AGENDA

MATANUSKA-SUSITNA BOROUGH

ABBREVIATED PLAT AGENDA ASSEMBLY CHAMBERS 350 EAST DAHLIA AVENUE, PALMER

May 7, 2025

Airstrip Way

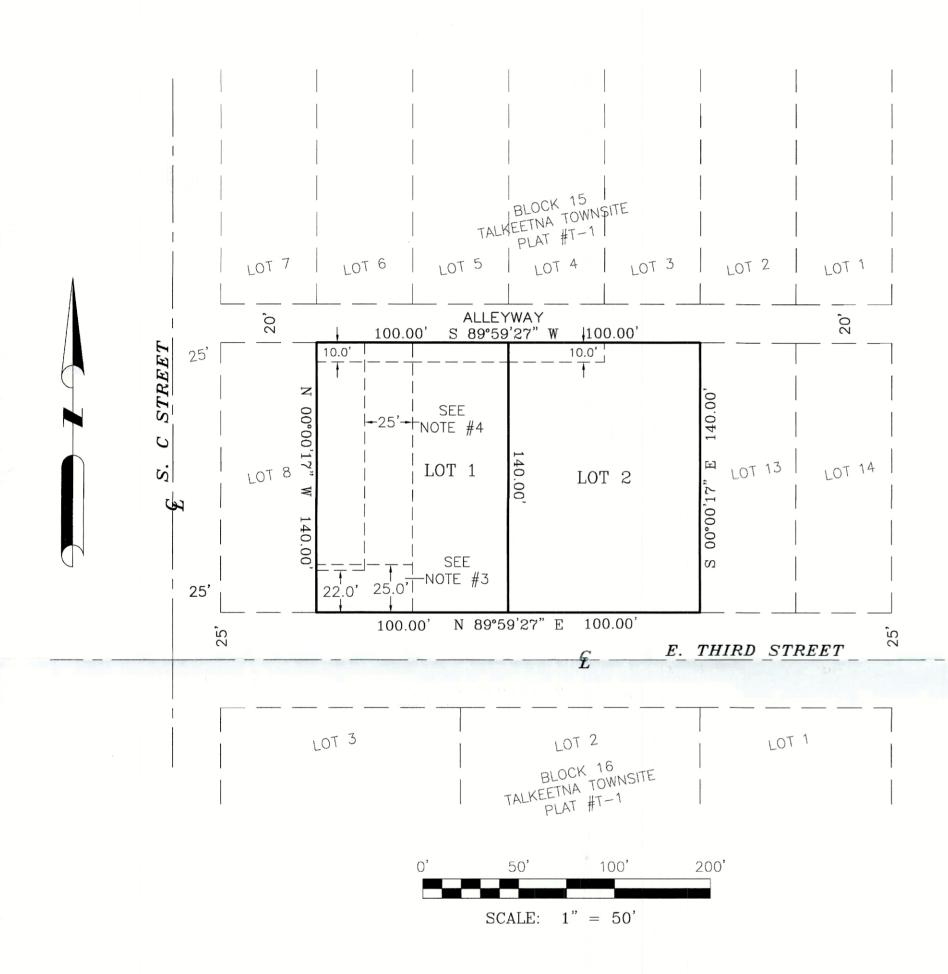
It looks like they may need another DW permit as shown, though it's tough to tell with the tree coverage.

<u>Code Compliance</u>: (Exhibit B) notes that there appears to be a non-permitted access onto Third Street. The petitioner will need to apply for driveway permits for all non-permitted accesses (Recommendation #4).

Dw'g. MeridianParkEast2025 B22-04 24FEB25 Drawn: MLK W.O. No. B22-04 | Sheet 1 of 1

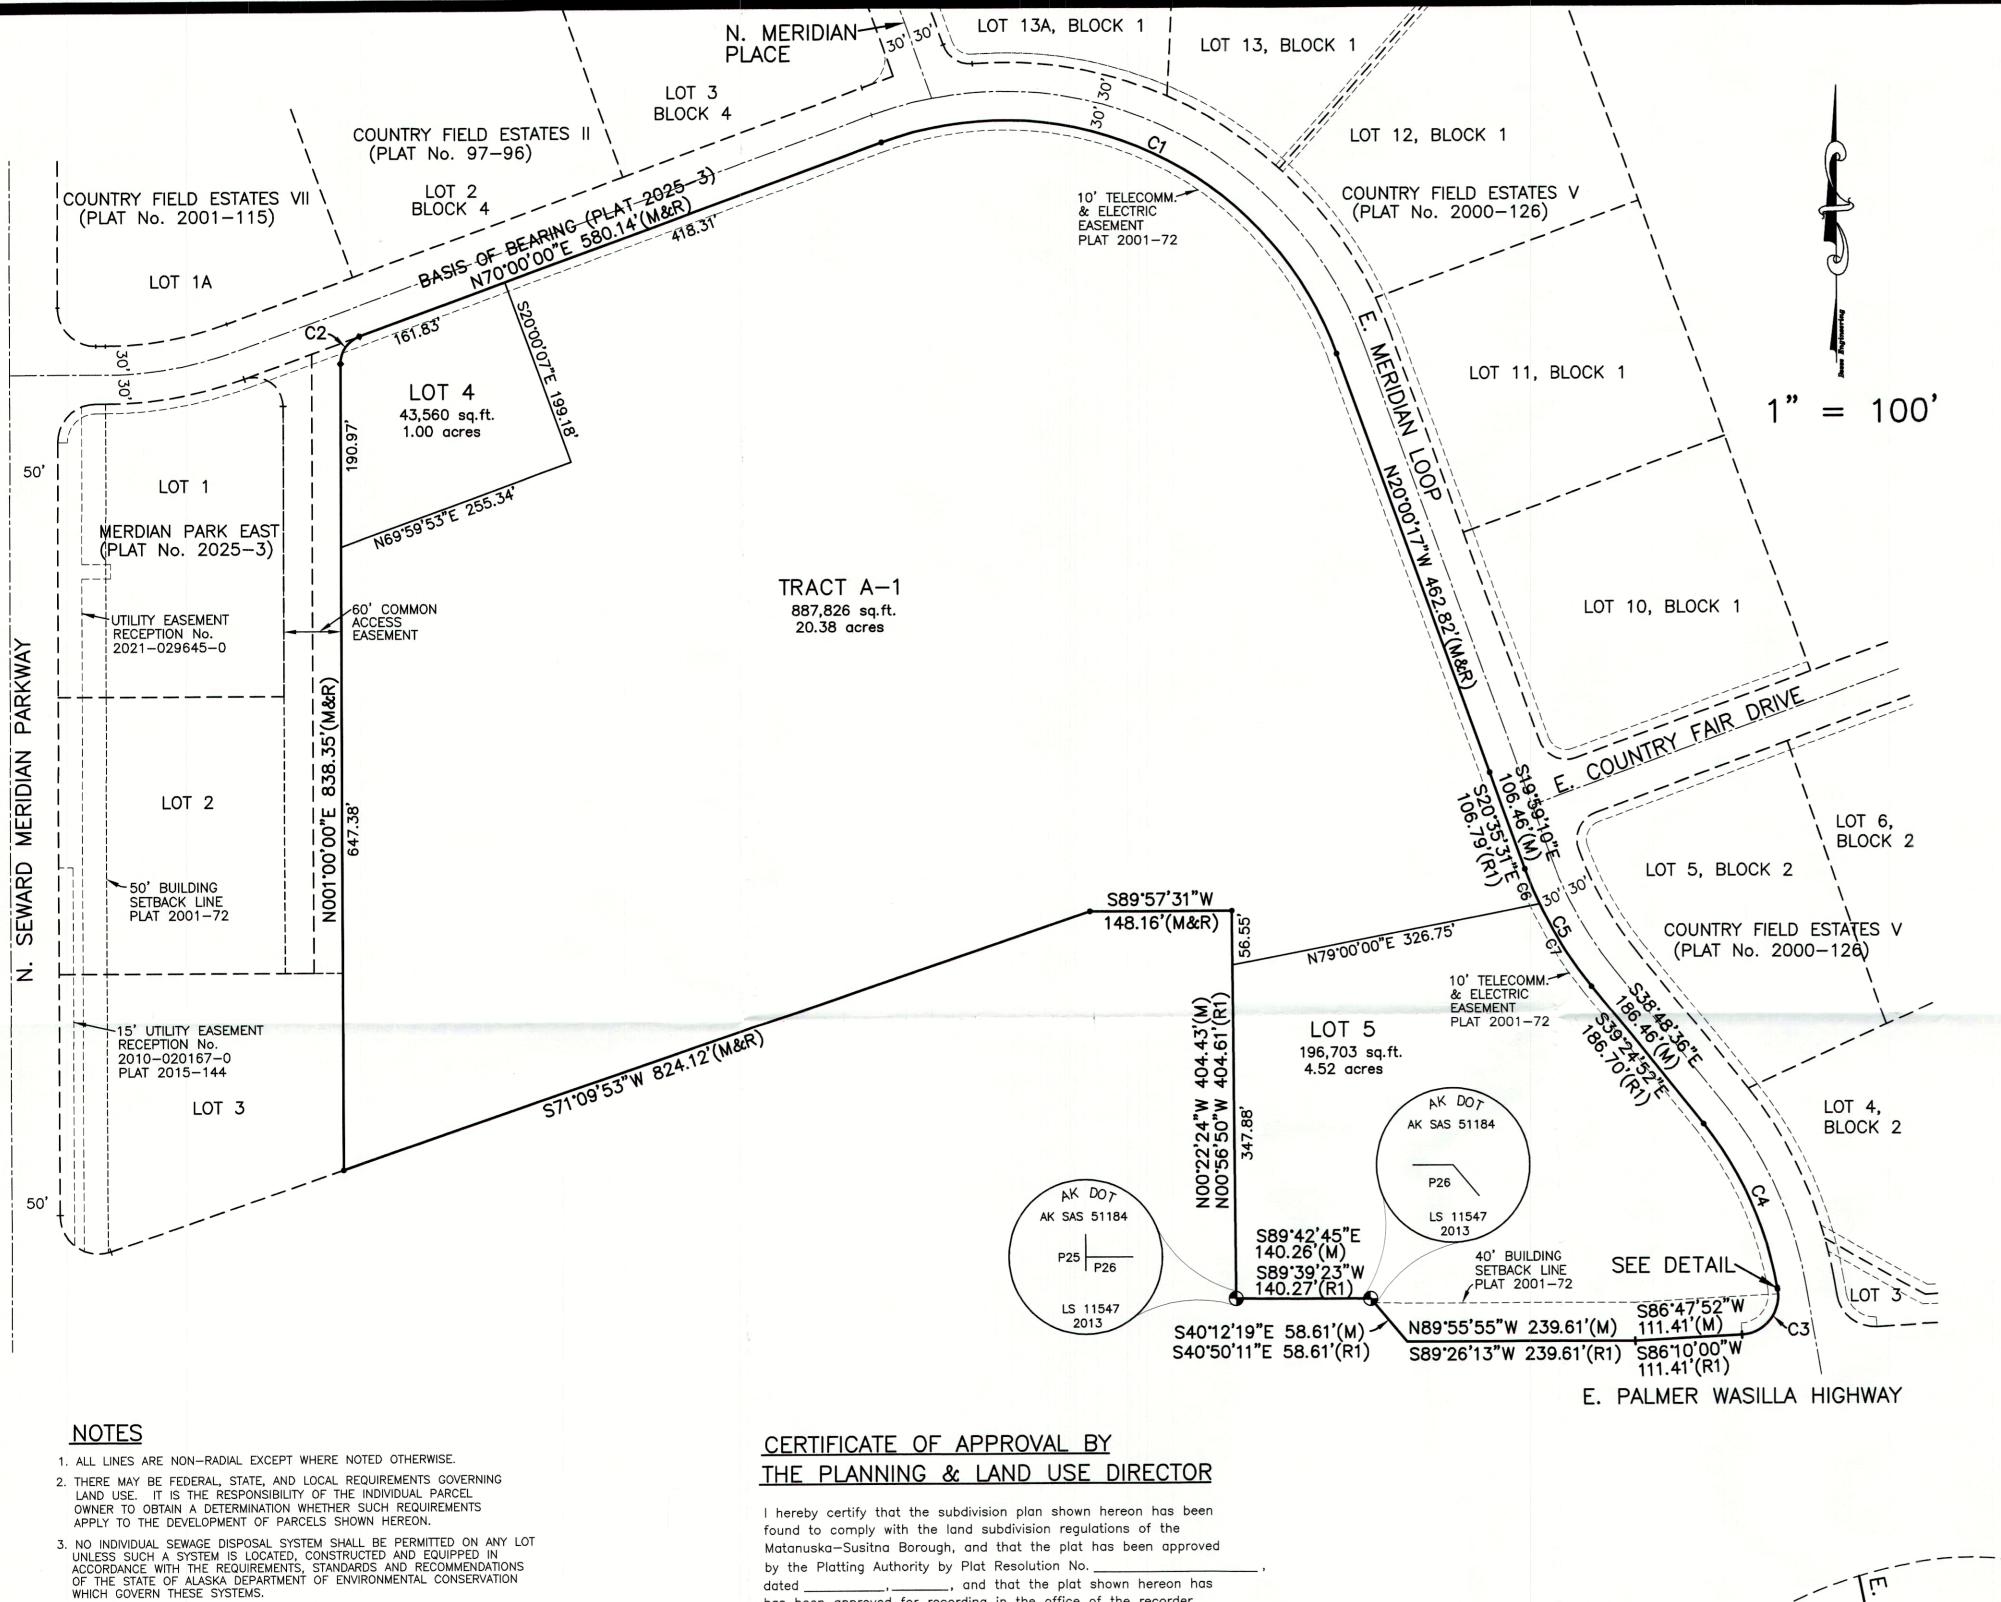
- Meridian Park East Addition No. 1; WA 10 Nugent; Plat 2025-3 & Plat 2001-72 (Palmer-Wasilla Highway)
 - DOT&PF notes that plat notes 4 and 7 are similar in intent and that only one is needed to meet DOT&PF plat note requirements regarding "No direct access to the Palmer-Wasilla Highway for all lots". DOT&PF prefers plat note 4 over plat note 7.

- o Recommend Lot 4 access through common access easement adjacent to Lots 1, 2 and 3.
 - Any future acquisition of connecting or adjacent parcels south of Tract A-1, Lot 3, and Lot 5 will also have a plat note requiring no direct access to the Palmer-Wasilla Highway and will require access through Meridian Loop and the common access easements in adjacent parcels.

PD&E recommends a note be placed on the plat that no direct access should be allowed to the Palmer Wasilla Highway.

Platting Staff notes that all applicable plat notes from the previous subdivision will carry forward and be noted on the final plat.
